IFB 3090

RUFFNER PROFESSIONAL DEVELOPMENT AND OPERATIONS CENTER REPURPOSING SERVICES

Addendum #6

PROJECT: RCPS Career and Technical Education Center

G2

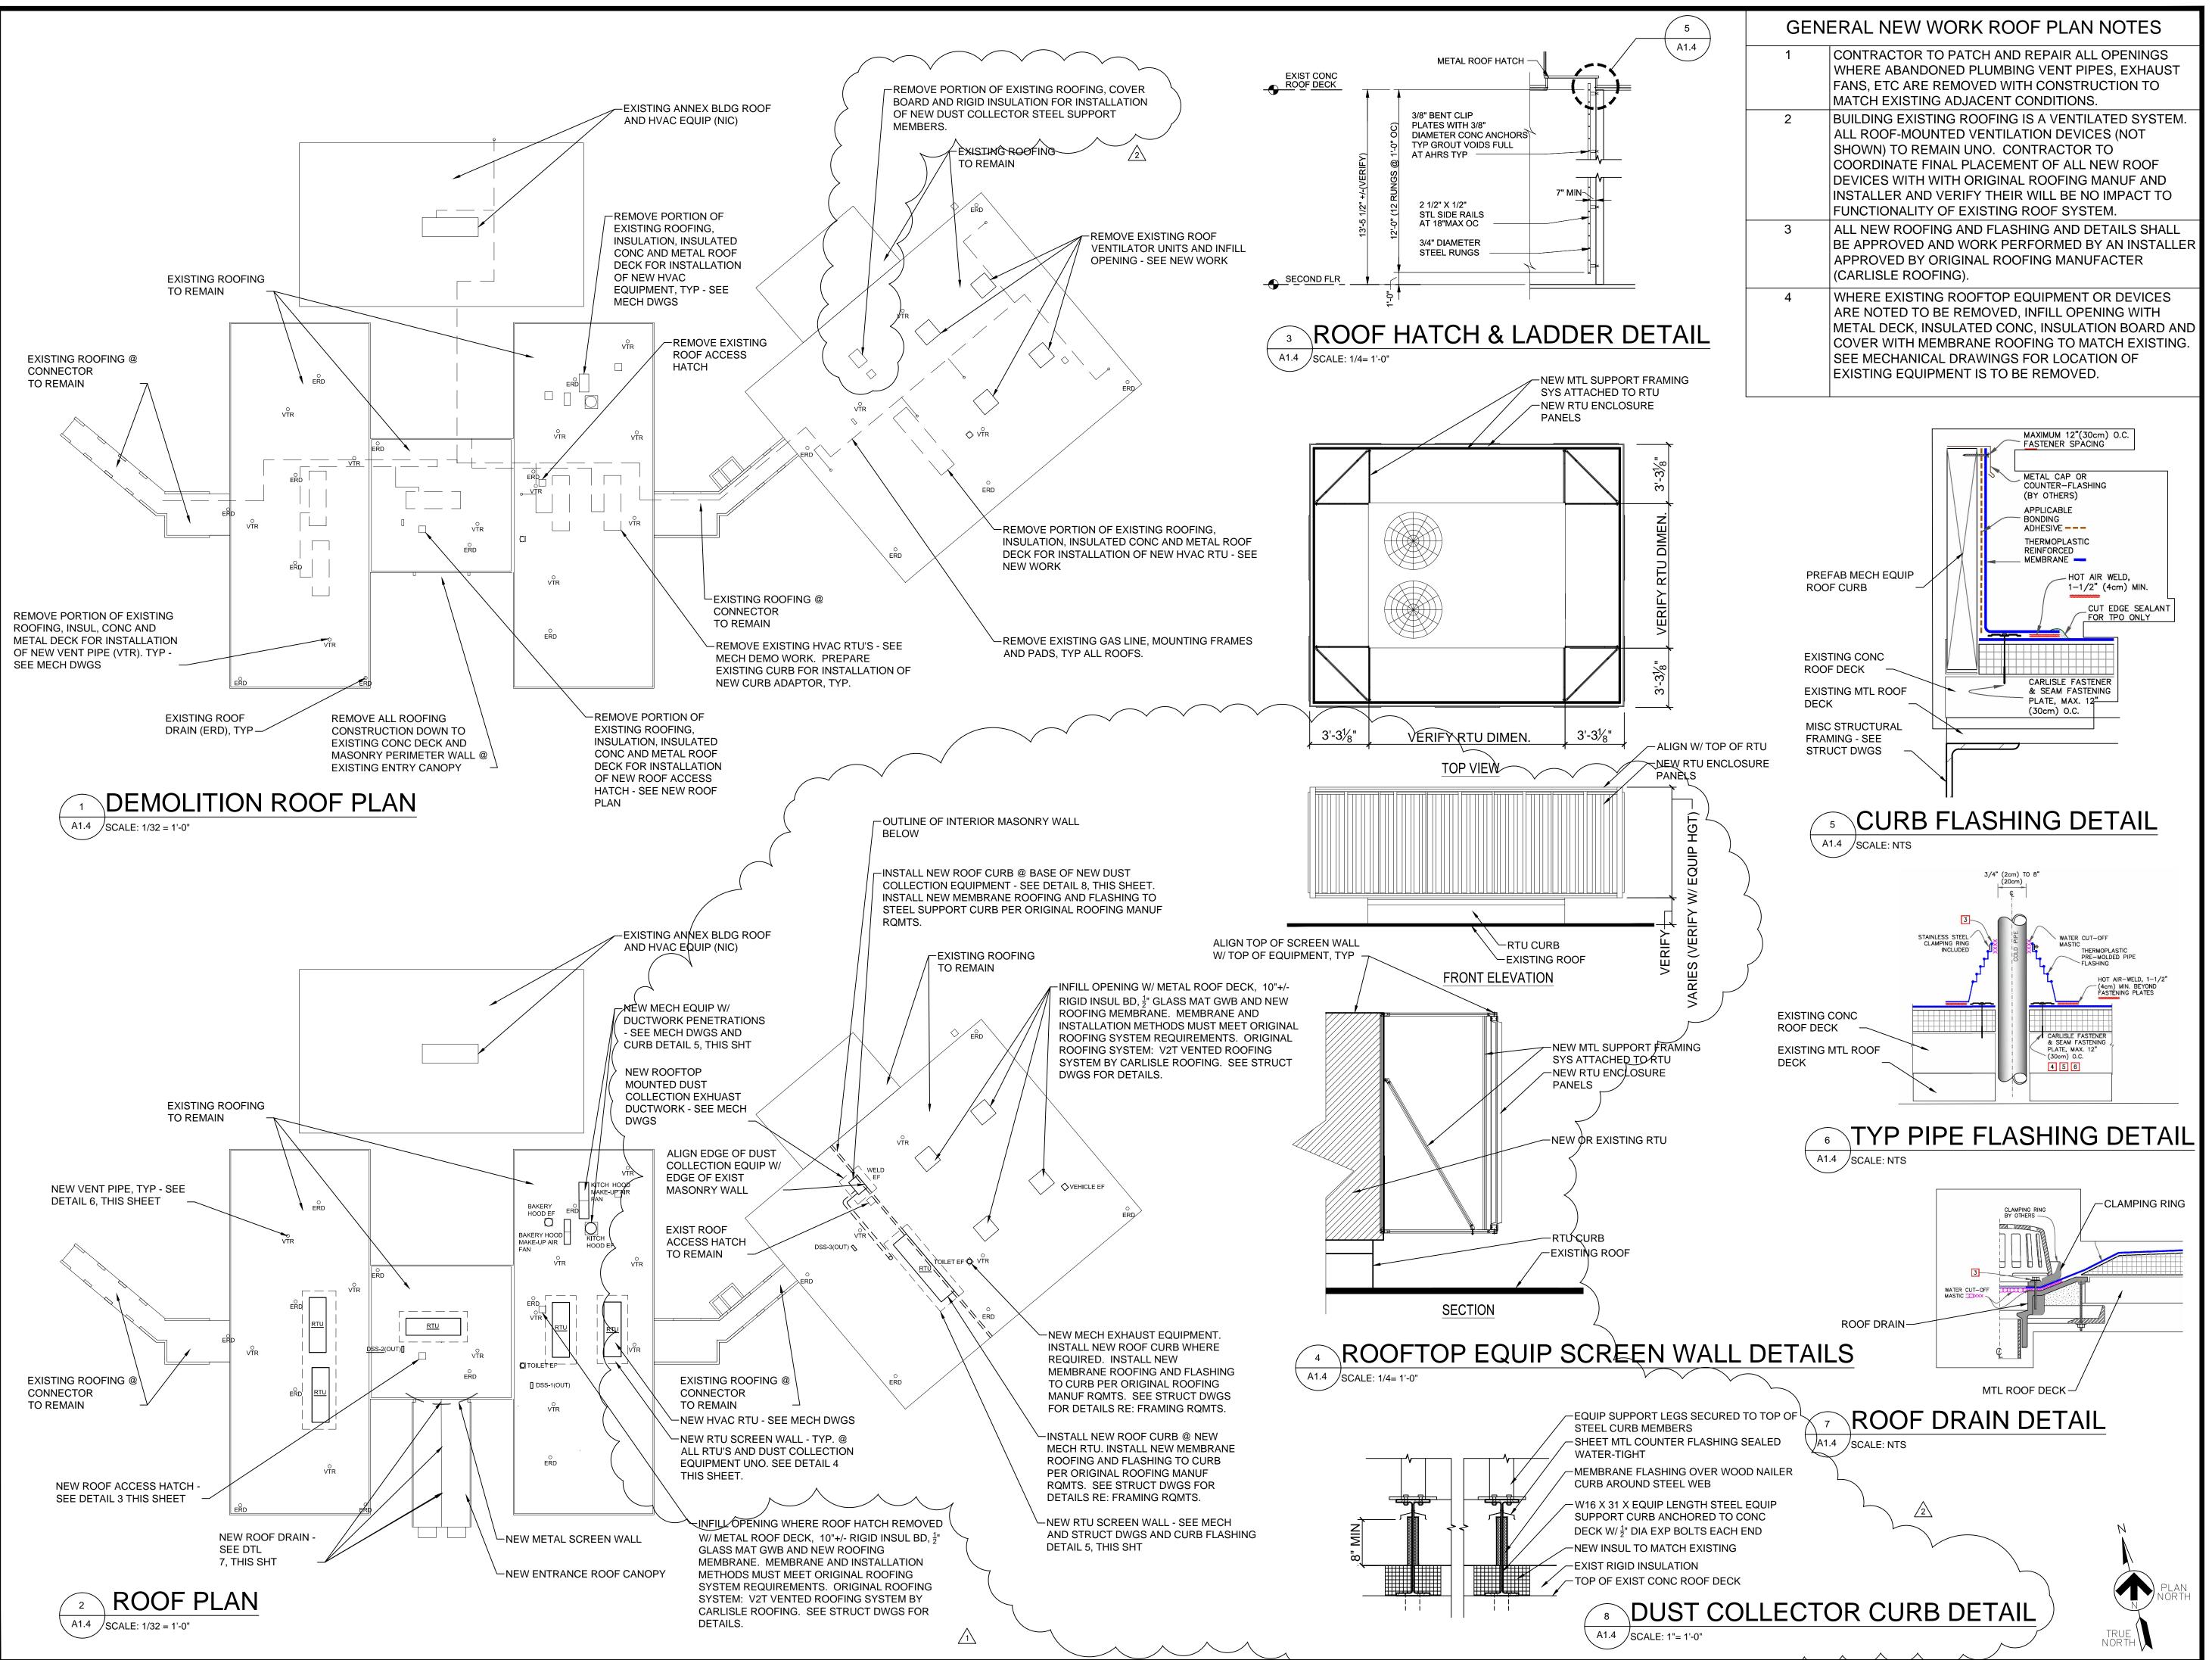
i. Replace following drawings with the revised drawings noted in Revision table as "Revision 6, 8/11/22, Addendum 6" included in Appendix A within this Addendum:

A1.4

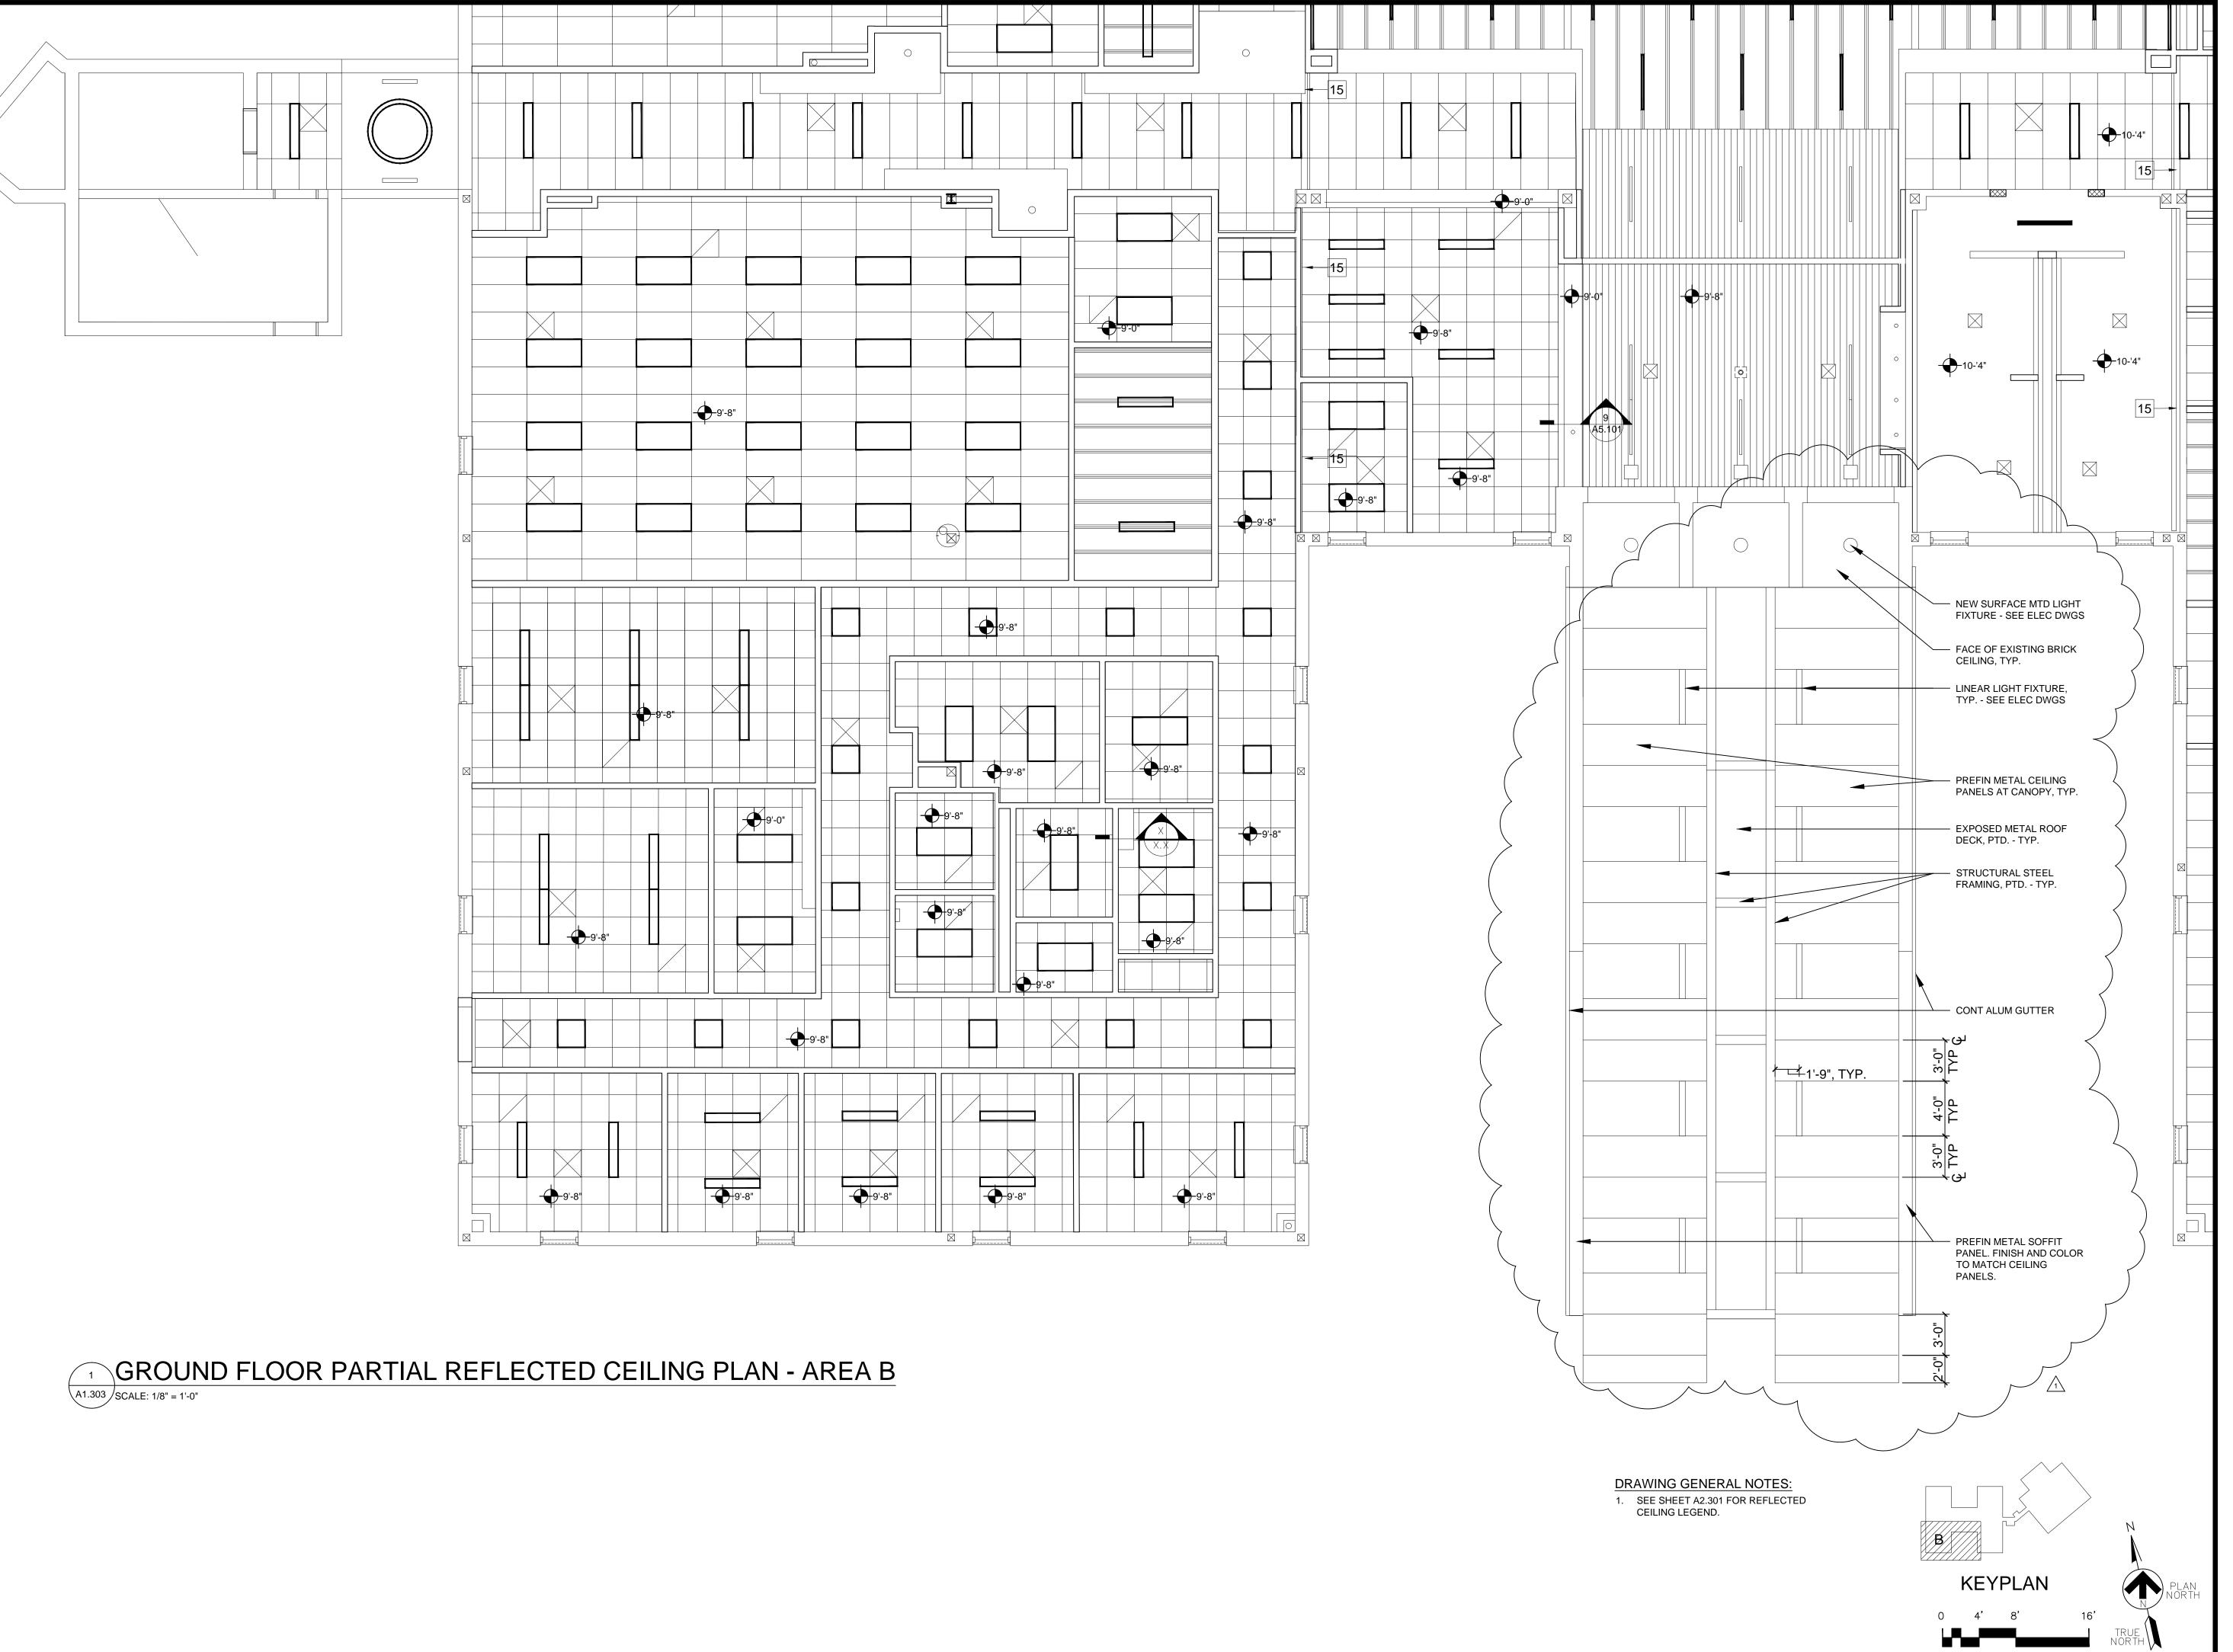
Please advise what window/storefront types are to be in these locations.	window type in .
29			Please provide a detailed drawing of how the Welding Dust Collector is to be secured to the	See revised Architectural Sheet A1.4 and M4.2 in Addendum 6. Note that the welding dust collector has
			building structure. I have not seen any revised documents showing additional structural steel	been relocated.
			for this.	
30			Please provide specifications for Screen Walls	See updated specification section 074213.13 - "Formed Metal Wall Panels" for screen wall requiirements.
31			Addendum 5, Q/A 8 States that the equipment screen walls as shown on A1.4 are to be	Screen wall systems are to be provided and installed by contractor. The screen wall system is to be provided
			purchased and installed by the successful bidder and where not pre-purchased with the Trane	at all sides of all rooftop HVAC units and the dust collector equipment.

equipment. Is the Trane equipment the only thing that requires a screen wall, A1.4 does not	
			show the Welding Dust Collector. Based on A1.4 units RTU-24 & 25 have a continuous screen	
			wall. This will have to be free standing and require additional structural support. Please provide	
32			drawings. Please clarify that Kitchen Hoods, fire suppression and interlock wiring are by others, not the	The boods and fire suppression system will all be bondled by the Food Foreignest Dealer. The dealer that
32			Mechanical.	The hoods and fire suppression system will all be handled by the Food Equipment Dealer. The dealer shall verify the fire suppression system is working properly before installation is complete. (Note: If the question
			imounamon.	centers on the fire suppression system and interlocking connections to the building fire alarm system, contacts
				are provided in the panel for those connections by others."
